**61 Mobbs Lane, Epping (former Channel 7 site) – Buildings 4 and 5,
Buildings 4 and 5 (MP08_0257 MOD 3)
Buildings 7 and 8 (MP10_0158 MOD 1)**

- MOD 3 – Strata subdivision – staged development
- MOD 1 – Strata subdivision

Director-General's
Environmental Assessment Report
Section 75W of the
Environmental Planning and Assessment Act 1979

November 2011

Figure 9: Proposed strata plan Building 4 level 1 (part)

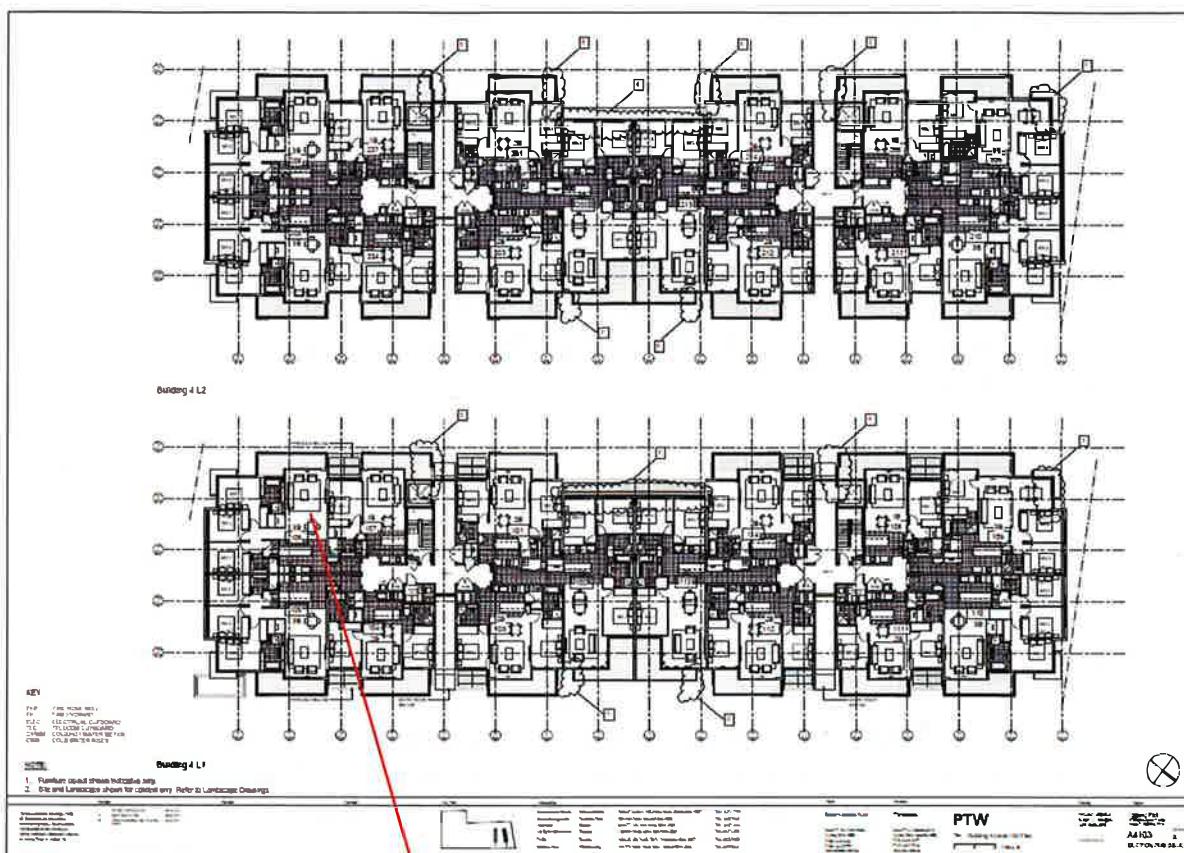
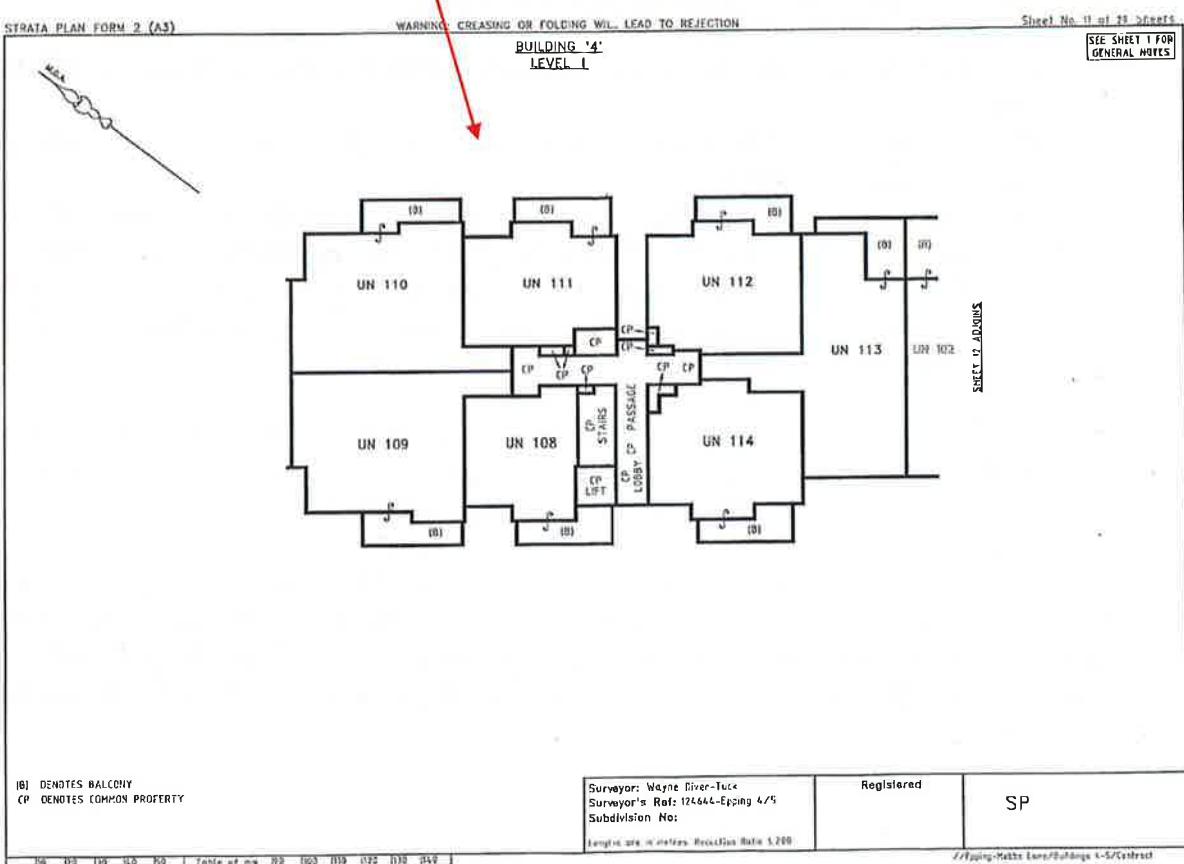
The department has reviewed the MOD 3 and MOD 1 strata plans and considers them to be generally consistent with the approved plans. On this basis, the proposed strata subdivision of buildings 4 and 5, staged subdivision of buildings 7 and 8 (MOD 3), and strata subdivision of buildings 7 and 8 (MOD 1) is considered appropriate and is supported.

Figure 13: Sheet 4 of 23 – Car park entrance is in north-western corner.

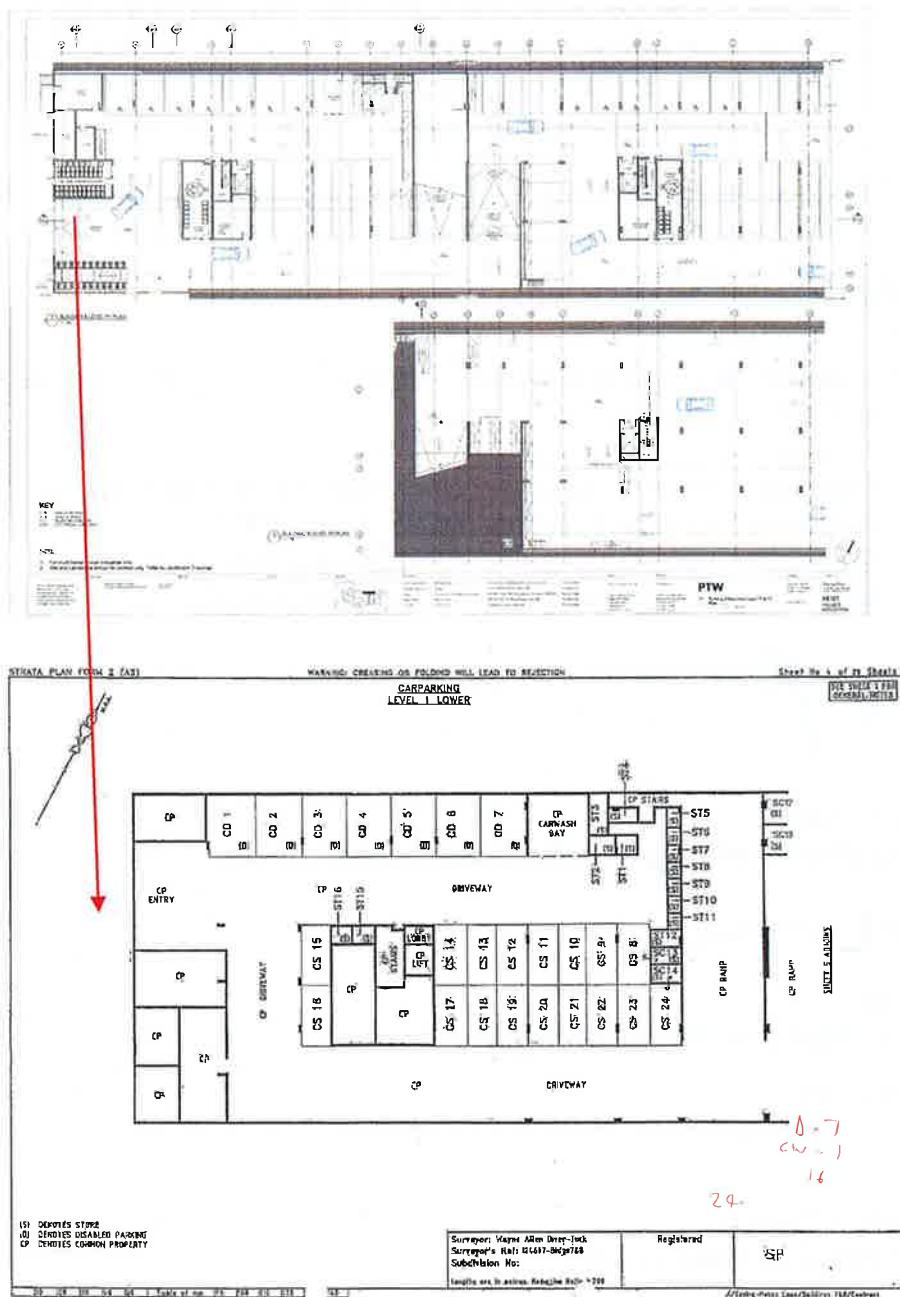
The department notes that while the car parking spaces are consistent with the approved plans, the entry and exit of the basement car park as shown on Strata Plan Sheet No.4 been shifted from the approved south-west corner of level 1 to the north-west corner of level 1. While both corners are illustrated as common property, the department considers changes to the entry and exit are inconsistent with the approved plans (Drawing A0011 & A8101).

Although it is a requirement of the Certifying Authority to ensure the approved plans are consistent with the strata plans prior to the issue of a Strata Certificate, the department will nevertheless impose a condition requiring Strata Plan Sheet 4 to be amended to reflect the approved car park entrance and entrance as shown on the approved plans. This will need to be submitted to the Director-General and certifying authority prior to the issue of a Strata Certificate.
